CONSERVATION TEAM CONSULTATION APPLICATION RESPONSE

APPLICATION REF:	26/00319/LBC
CASE OFFICER:	TH
APPLICATION SITE:	Barn to the west of Lordship Farmhouse, Pirton Road Holwell, Hertfordshire
DESCRIPTION OF WORKS:	Conversion of a grade II listed building and associated building to create two semi-detached dwellings (1 x 3 bed and 1 x 4 bed) including demolition of modern extension and replacement single storey extension. Internal and external alterations.

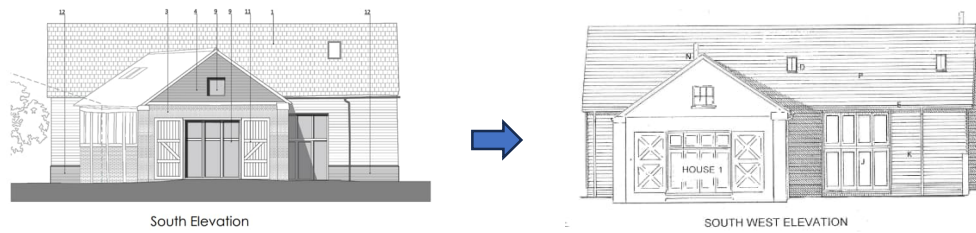
I am satisfied that the Southwest Elevation will work well. Ledged-and-braced as opposed to cross-braced doors may be lightly better for the large 'shutter' doors but that is a minor

point (see doors below on main barn). Regarding the floor plan for House 1, the 'shutter' doors to the gable end are not shown and I also queried on site the ceiling height of the rooms in this unit.

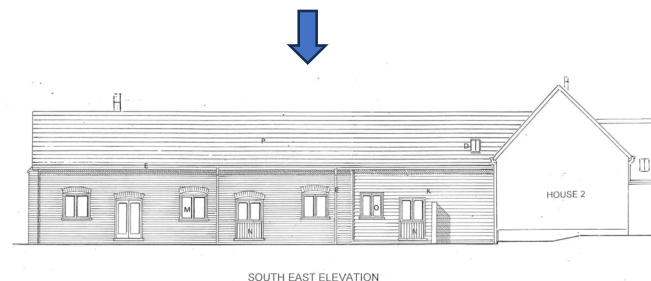
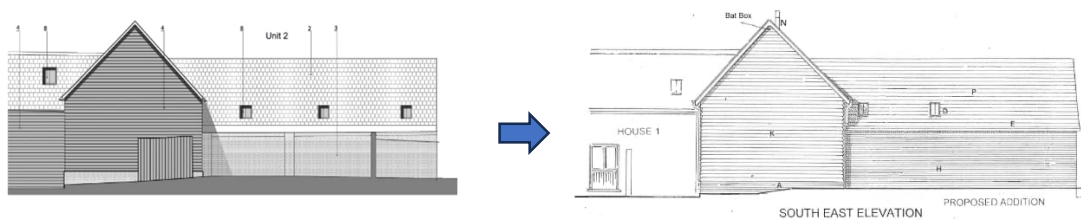
I also raise no objection to the fenestration for the Southeast Elevations below.
